MILITARY SPECIFICATION

RECEIVER, RADIO (RADIO RECEIVER R-390()/URR)

This amendment forms a part of Military Specification MIL-R-13947B(SigC)
dated 26 October 1960

Amend 7 to
MIL-R-13947B(SigC)

FIGURE 1

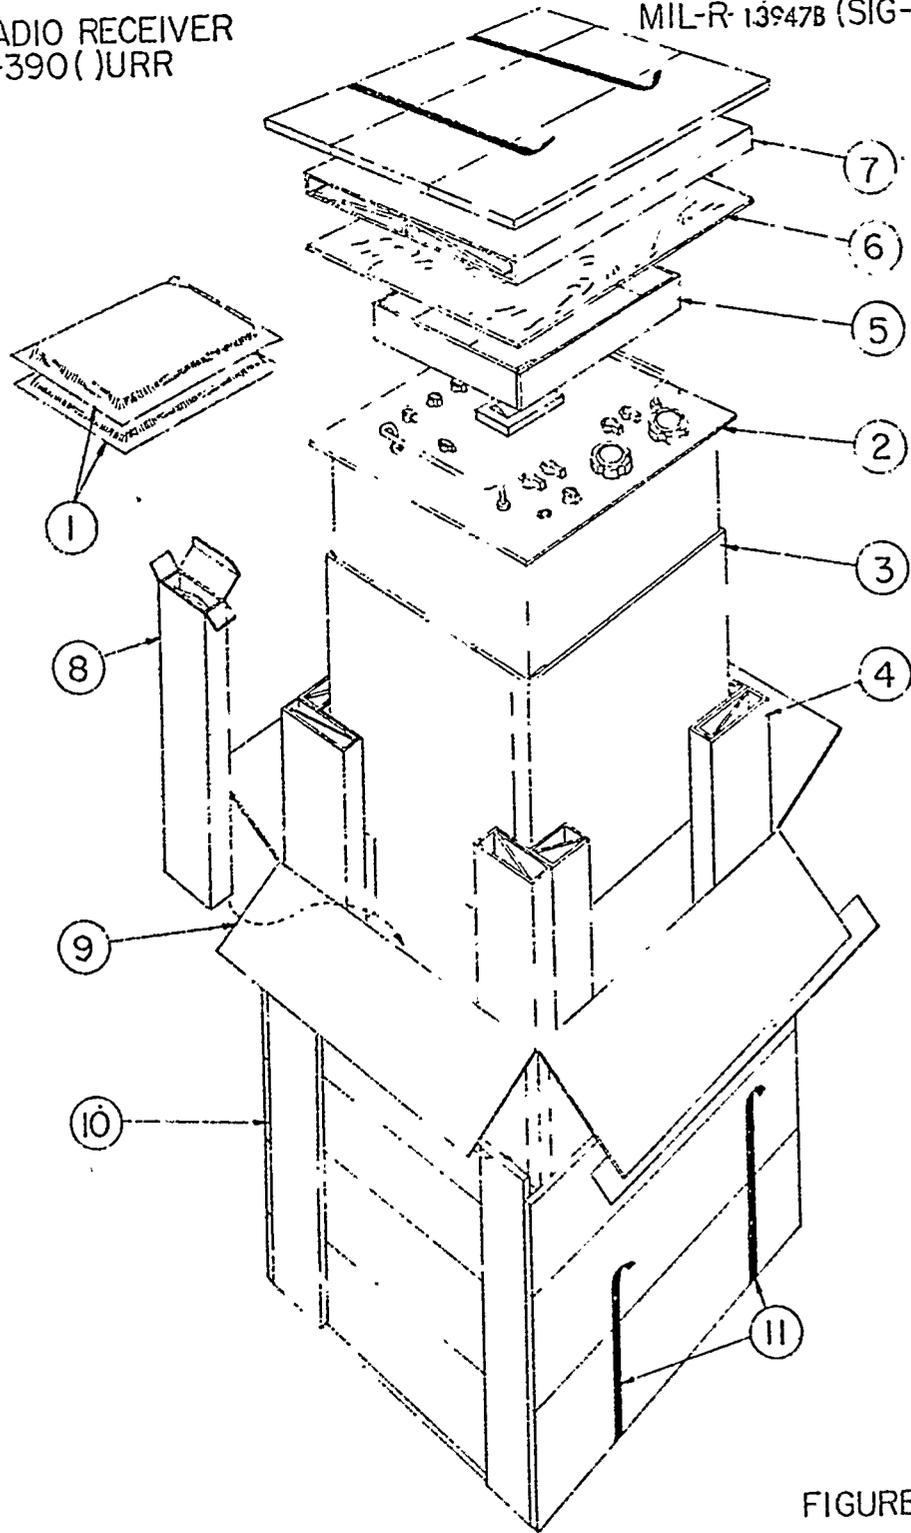
50. Page 37, 38 and 39: Delete, and replace with:

5.1.1 Level A.- Each Radio Receiver R-390()/URR shall be packaged in accordance with Items 1 through 9, Figure 1 and Table I.

5.2.1 Level A.- Each Radio Receiver R-390()/URR shall be packed in accordance with Items 10 and 11 of Figure 1 and Table I. Box closure shall be as specified in the appendix of the applicable box specification.

5.2.2 Level B.- Each Radio Receiver R-390()/URR shall be packed in accordance with Item 10 of Figure 1 and Table I, except nailed wood box shall be class 1, Style 4, or cleated plywood box, Style A, Type IV, class 1.
